REMARKS

ATTY DKT. NO.: INFN/SZ0017
J.S. SERIAL NO.: 10/716,749
FILED: NOVEMBER 19, 2003
TITLE: INTERNAL VOLTAGE GENERATOR WITH TEMPERATURE CONTROL
INVENTOR(S): JUNG PILL KIM ET AL.
CONF. NO.: 6180
SHEET 2 OF 8

FIG. 2

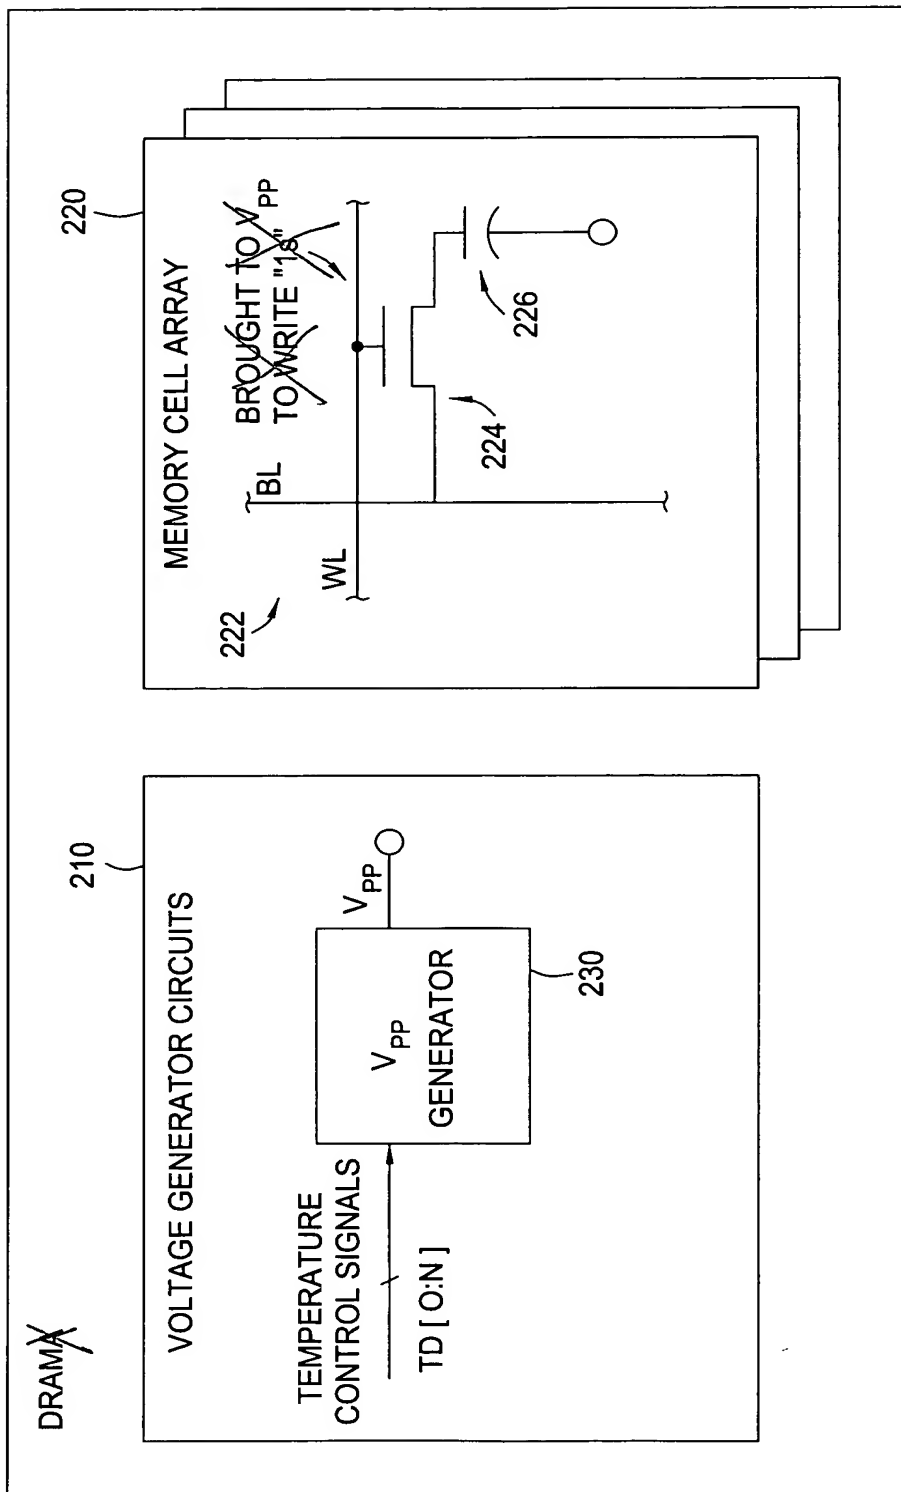
The drawings are objected to as failing to comply with 37 CFR 1.84(p)(5). Replacement sheets for FIGs. 2 and 7 are submitted herewith to correct and remove the objected to reference characters. Regarding the Examiner's objection to reference signs in the specification TD[0:3] not included in the drawings, Applicants have amended the specification to clarify that TD[0:3] is an example of signals TD[0:N] with N=3. Standard nomenclature was used in the specification to describe operation of the illustrated embodiment when these signals have exemplary values, such as b'0010' (i.e., TD[0]=0, TD[1]=0, TD[2]=1, and TD[3]=0).

The attached sheets of drawings includes changes to Figure 2 and Figure 7.
